Site Plan Review Committee (SPRC) Staff Report for Arva (2201 Arlington Blvd)

Item 1. SPLN22-00006
(RPC# 18-059-020)
Planning Commission and County Board meetings to be determined.
Peter Schulz (CPHD Staff)

Arva SPLN22-00006
(RPC# 18-059-020)

Figure 2-- Ground plan, courtesy applicant

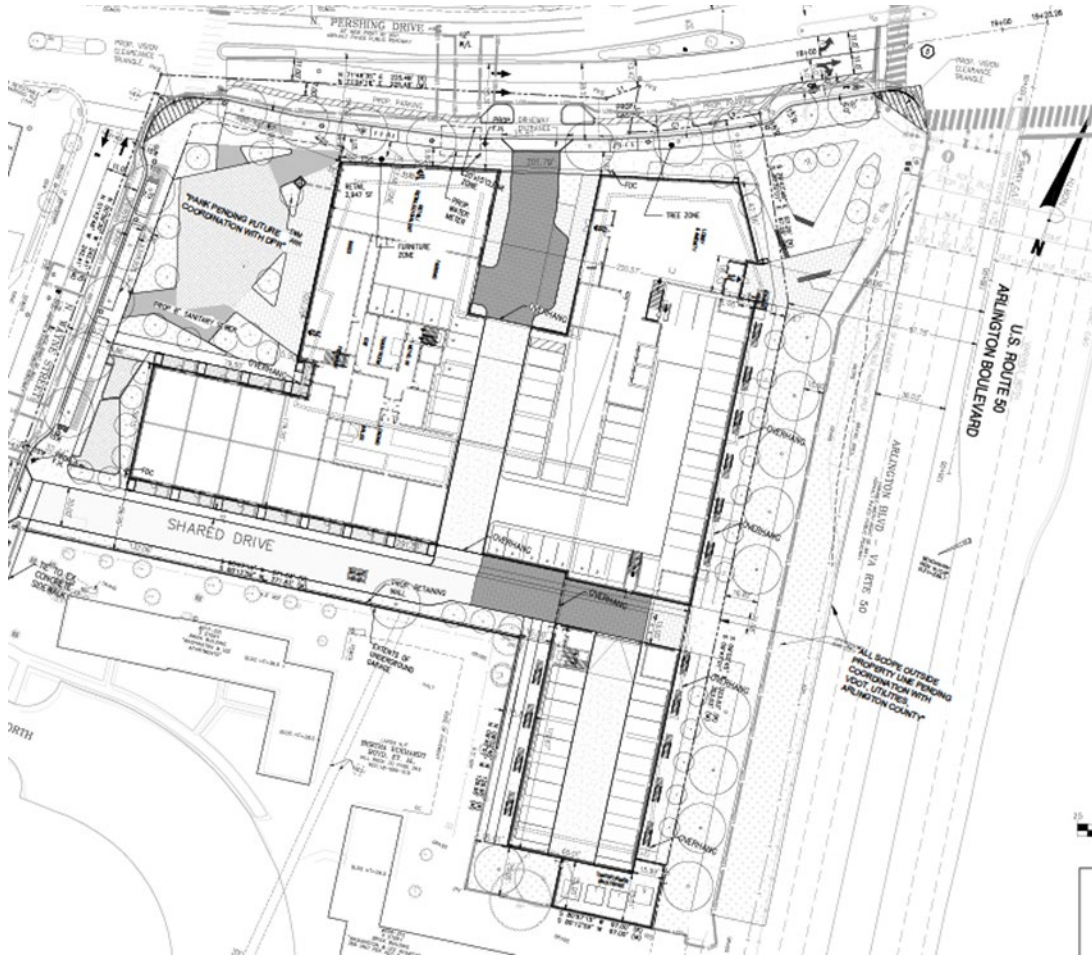
- Architecture/Urban Design: Areas of above grade parking create occasional blank walls and awkward urban design;
- Architecture/Urban Design: The architecture, especially above the second level, does not do enough to either reference the mid-Century architecture of the existing motel, nor the colors and architectural vocabulary of the earlier Washington-Lee Apartments.

- Architecture/Urban Design: The developer proposes to recreate the historic sign and lobby. Staff would like to see evidence that the existing structures are too fragile to re-use.

- Public Space/Landscaping: The proposed public space includes areas for internal pedestrian site circulation and is also immediately adjacent to the retail space.

- Public Space/Landscaping: The proposed areas for the electrical transformers, while underground, create an area adjacent to both the Washington-Lee Apartments and the Arlington Boulevard façade that cannot be planted.

- Public Space/Landscaping: Landscaping does not entirely meet the recommendations of the GLUP Study document, especially on the south property line.
- Public Space/Landscaping: Can the proposed private dog run be moved elsewhere on the property? As proposed, it may need a taller fence to prevent dogs from escaping, which would have negative effect on the streetscape and the pedestrian experience walking on that side of North Wayne Street. It would also permit dwelling units adjacent to it to have windows or door openings onto that side of the façade. A dog run at an upper level of the building might also be easier for the building owner to treat waste and install AstroTurf for easier cleaning.
